INFORMATION REQUEST RESPONSE

RESPONSE TO INFORMATION REQUEST – 44 WARREN STREET, ST LUCIA (APPLICATION REFERENCE - A007038499)

Figure 1: The refuse bins located within verge. A 0.9m x 0.9m dimension per bin was used.

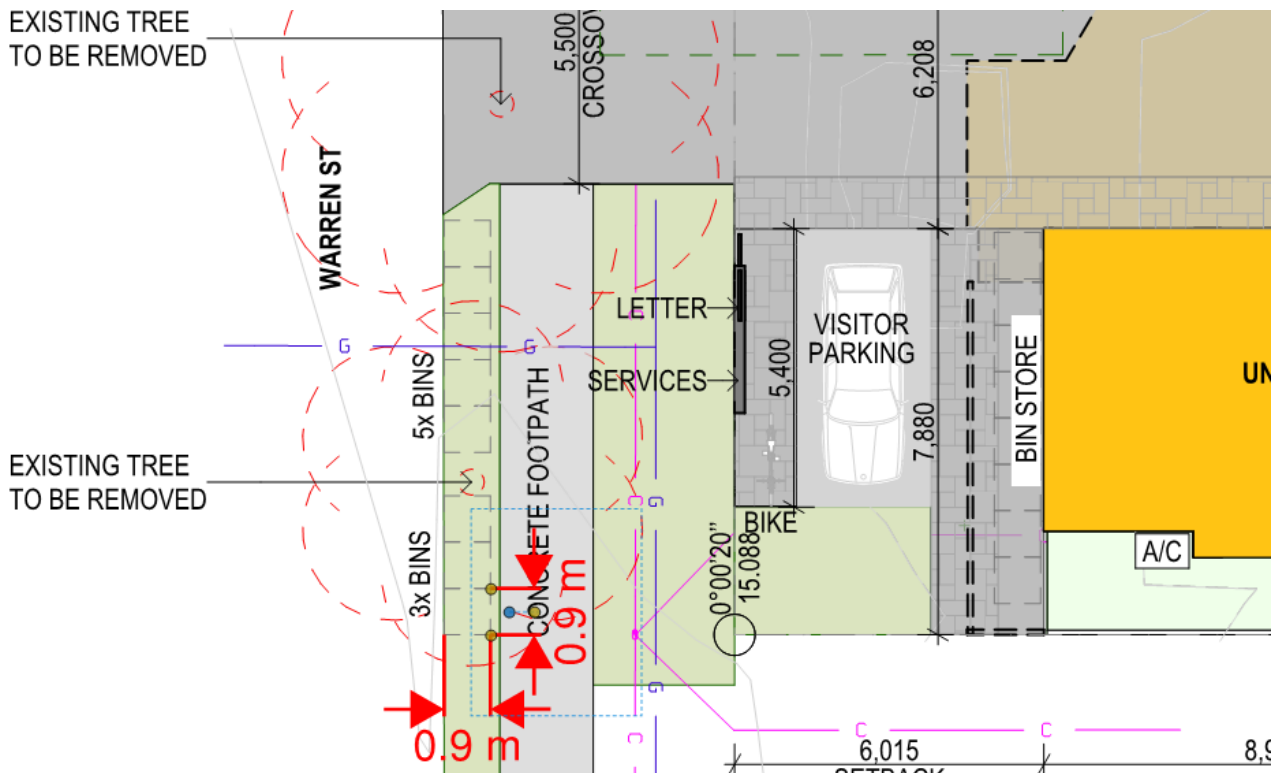
- 3) Kerbside refuse collection is proposed; however, it is unclear whether sufficient kerbside space is available due to potential conflicts with existing street trees and the proposed vehicle crossover.*
- a) Submit revised plans clearly identifying the bin presentation area within the site frontage. The plans must show all existing street trees and the proposed crossover, and include dimensions as required by AO8.1 of the Infrastructure design code.*

As shown in Figure 1, there is sufficient space to accommodate the refuse bins along the kerbside. We note that a street tree will need to be removed.

As per item 5 of the information request, Council included a note stating that they would advise on the removal of the street tree. Given we have not heard anything further, it is assumed that the street tree is permitted to be removed.
